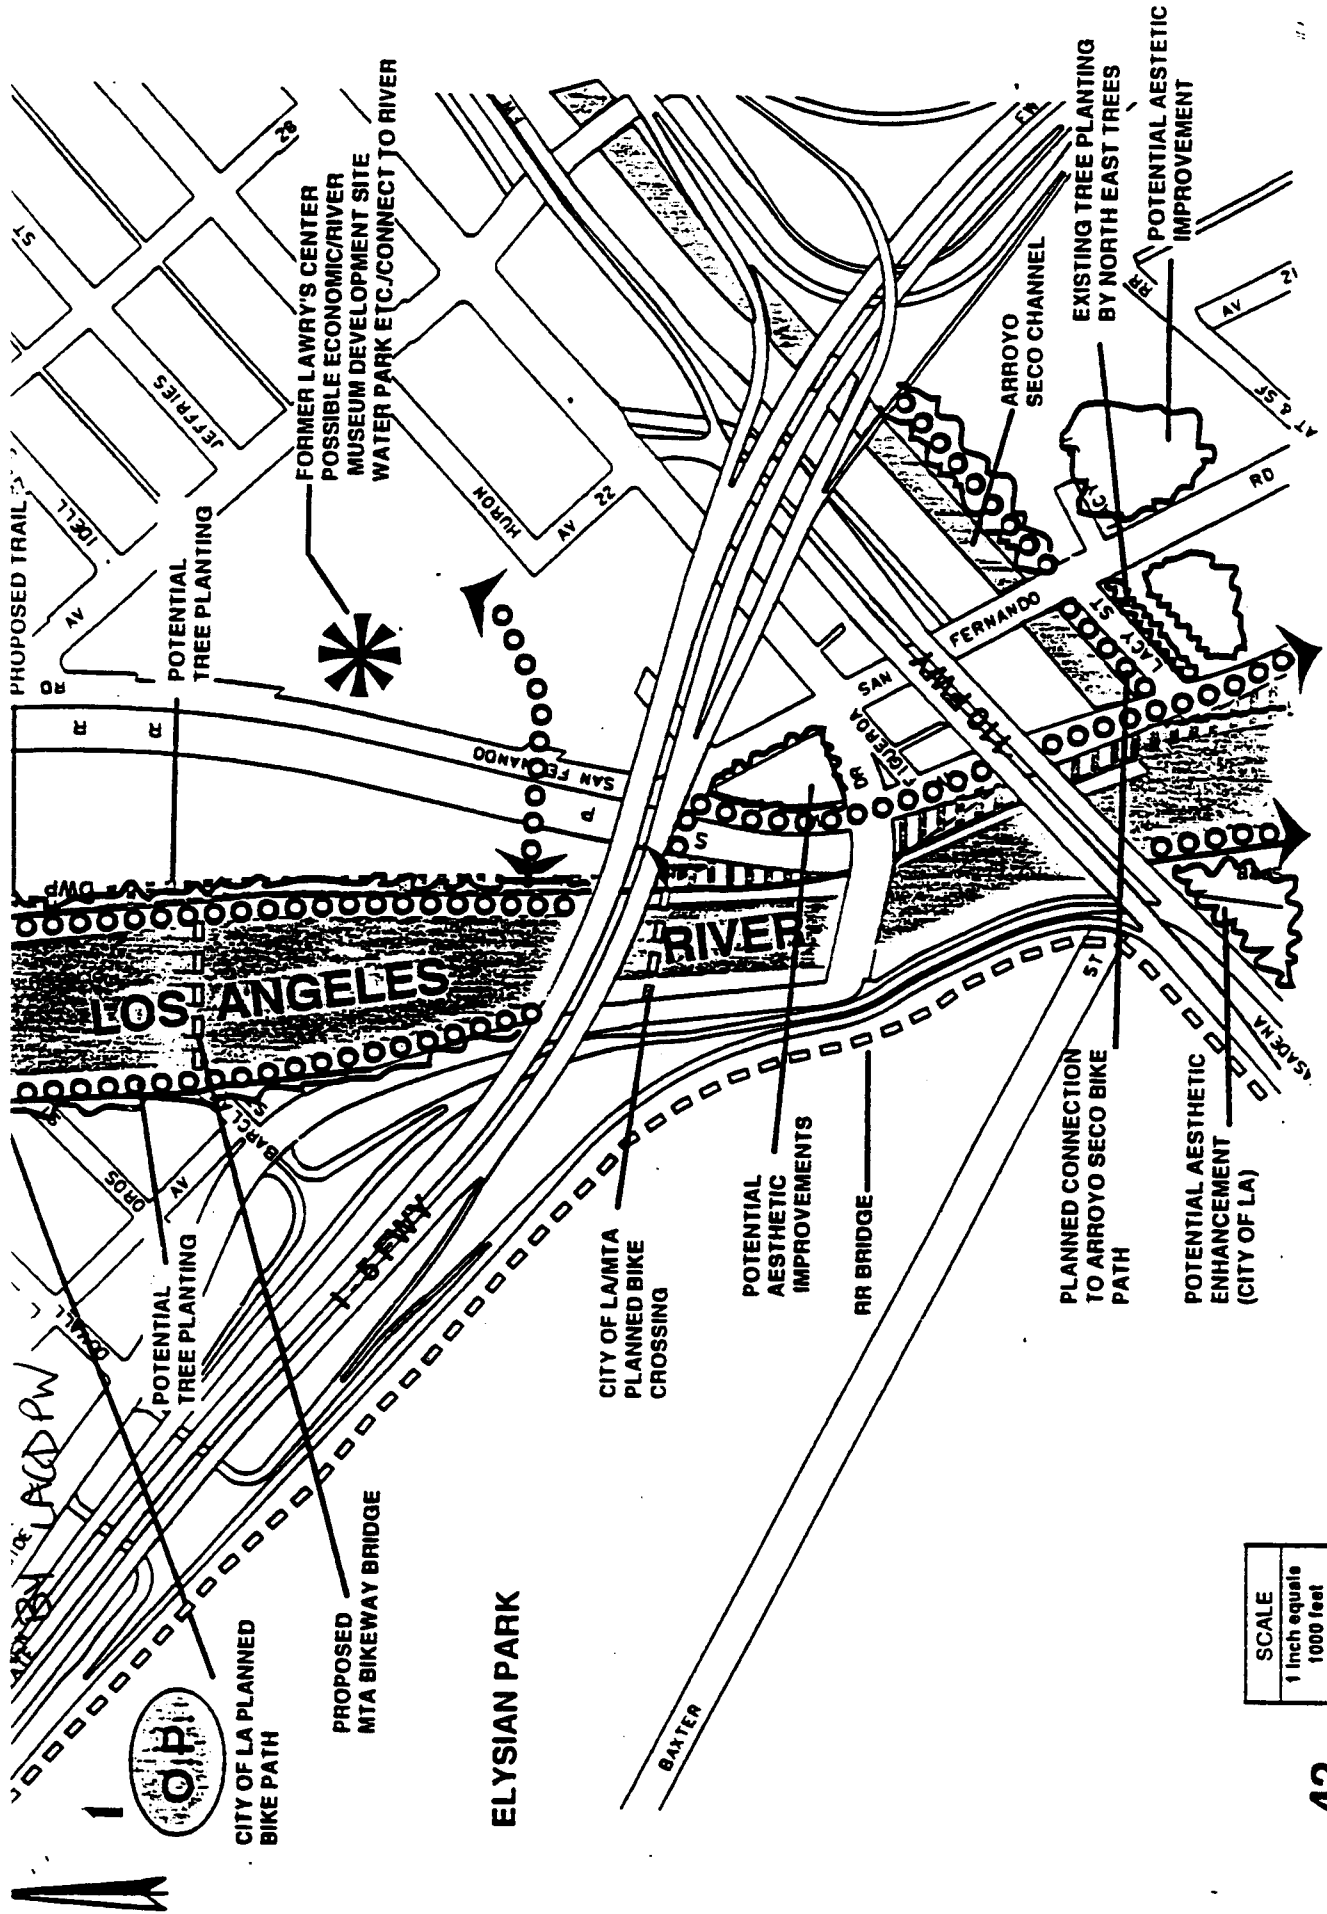
- Corresponding changes have been made to the Master Plan.
- Section 2.3, Sheet 48      This sheet has been amended to include location of facilities identified by The Metropolitan Water District of Southern California. Corresponding changes have been incorporated in Figures 5.12-1 through 5.12-7 of the Programmatic Negative Declaration and Environmental Assessment.

- This sheet has been amended to illustrate transmission line (TL) and right-of-way (RW) information provided by the Department of Water and Power of the City of Los Angeles.

- Corresponding changes have been made to the Master Plan.
- Section 2.3, Sheet 57      This sheet has been amended to illustrate transmission line (TL) and right-of-way (RW) information provided by the Department of Water and Power of the City of Los Angeles.

- Corresponding changes have been made to the Master Plan.
- Section 2.3, Sheet 58      Change "Existing City of Burbank Equestrian Trail Bridge Improvement of Safety Fencing Needed" to "Potential Bridge Crossing."

- Section 2.3, Sheet 60      This sheet has been amended to include location of facilities identified by The Metropolitan Water District of Southern California. Corresponding changes have been incorporated in Figures 5.12-1 through 5.12-7 of the Programmatic Negative Declaration and Environmental Assessment.

- This Warner Bros. portion of the map has been amended as follows:  
Other Projects: Warner Bros. Studios Main and Ranch Lot Master Plans.
- The two Economic Development areas that were identified within the Warner Bros. Studios Main and Ranch Lot Master Plans have been relocated to the County easement areas.

- Corresponding changes has been made to the *Master Plan*.
- Section 2.3, Sheet 66      Change "Potential Riverside Park" to "Existing commercial - Potential aesthetic, economic and/or recreation improvements to connect with trails and river."

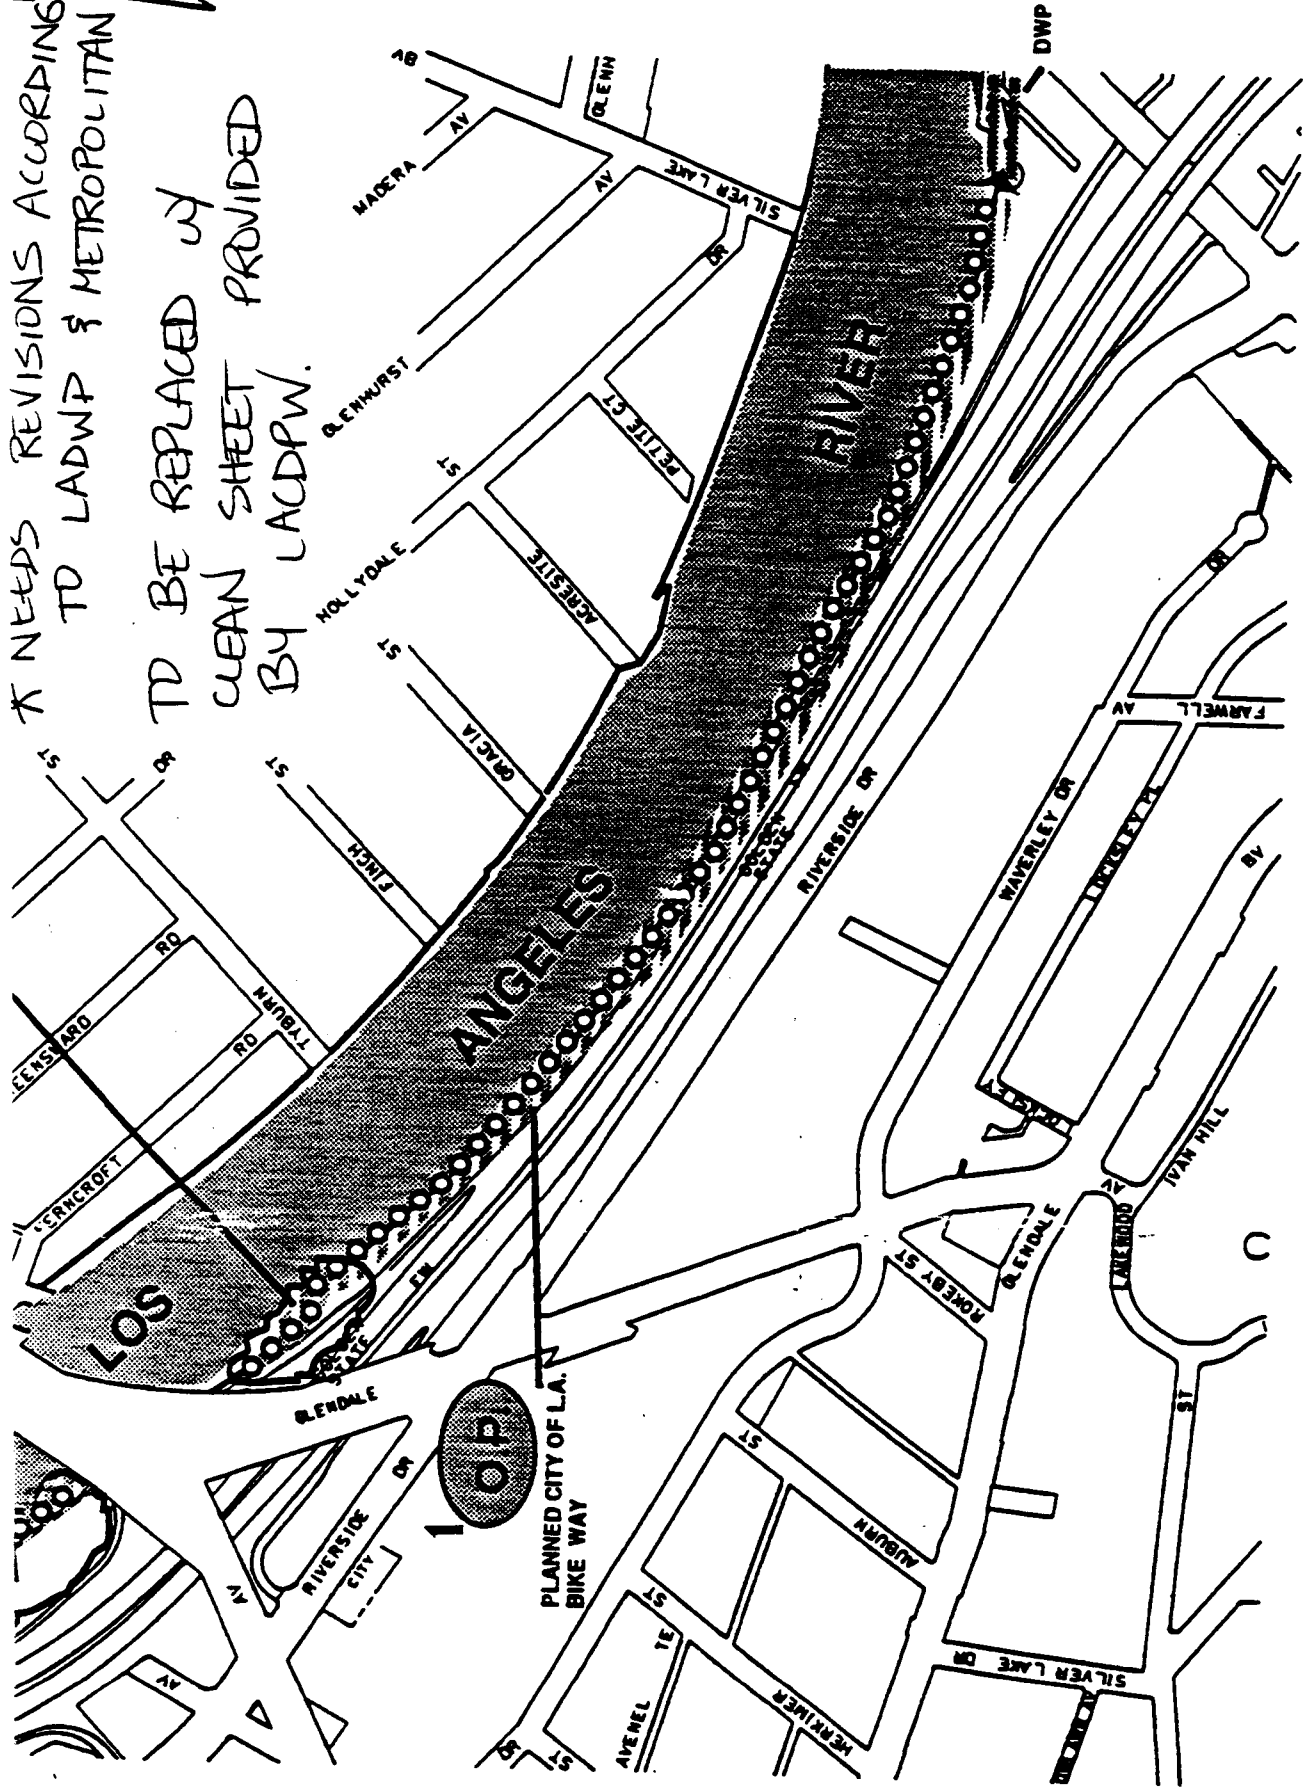
\* NEEDS REVISIONS ACCORDING TO LADWP & METROPOLITAN \*  
 TO BE REPLACED BY  
 CLEAN SHEET PROVIDED  
 BY LACDPW.

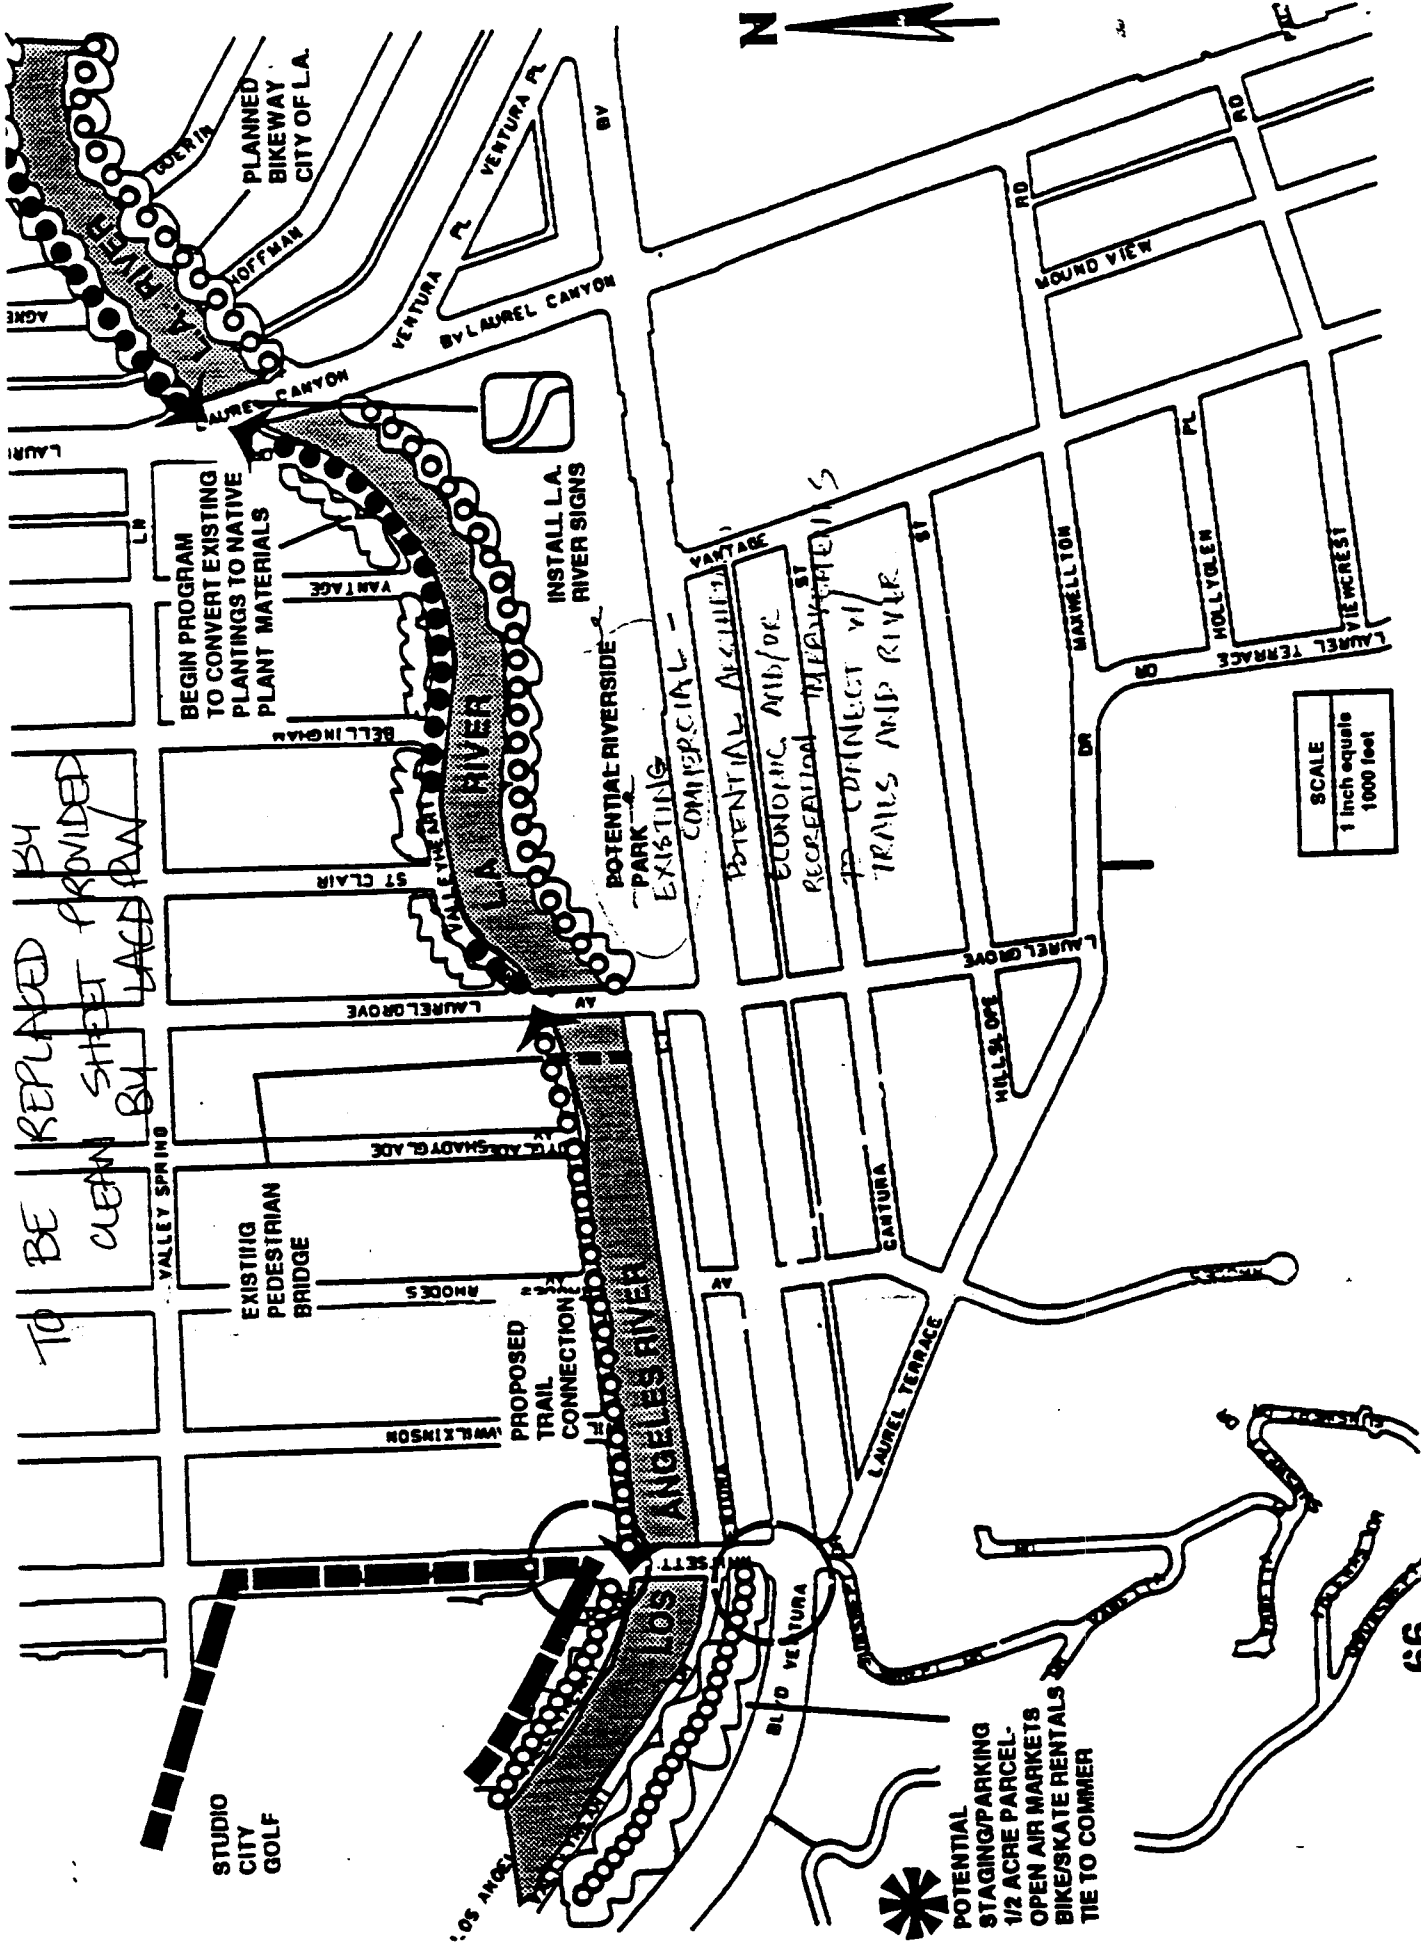
Section 2.3, Sheet 72	This sheet has been amended to include location of facilities identified by The Metropolitan Water District of Southern California. Corresponding changes have been incorporated in Figures 5.12-1 through 5.12-7 of the Programmatic Negative Declaration and Environmental Assessment.
Section 2.3, Sheet 73	This sheet has been amended to include location of facilities identified by The Metropolitan Water District of Southern California. Corresponding changes have been incorporated in Figures 5.12-1 through 5.12-7 of the Programmatic Negative Declaration and Environmental Assessment.
Section 2.3, Sheet 82	This sheet has been amended to illustrate transmission line (TL) and right-of-way (RW) information provided by the Department of Water and Power of the City of Los Angeles.  Corresponding changes have been made to the Master Plan.

Sheet 2.3, Sheet 98	This sheet has been amended to include location of facilities identified by The Metropolitan Water District of Southern California. Corresponding changes have been incorporated in Figures 5.12-1 through 5.12-7 of the Programmatic Negative Declaration and Environmental Assessment.
Table 2.2-1, (Page 2-22)	Change "Potential Riverside Park" to "Existing commercial - potential recreation improvements to connect with trails and river." Add under "Aesthetic Improvement" header, "Potential aesthetic improvements". Add under "Economic Development" header, "Potential economic improvements".
Table 2.2-1, (Page 2-26)	Change "coninuing" (sic) to "continuing" and change "Interpretive site at top of Hansen Dam with access from Hanse (sic) Dam at Osborne St." to "Interpretive site at top of Hansen Dam, with access available at Osborne St".
Section 5.1.1, (Page 5-4)	Add after first paragraph, "The Los Angeles River lies within a larger watershed. The <i>Angeles National Forest Land and Resources Management Plan</i> was completed in 1987 for portions of the watershed that lie within the Angeles National Forest. Although the Los Angeles River Master Plan area lies outside the Resources Management Plan, the Angeles National Forest has indicated the importance of compatibility between the individual plans and the overall management of the area.
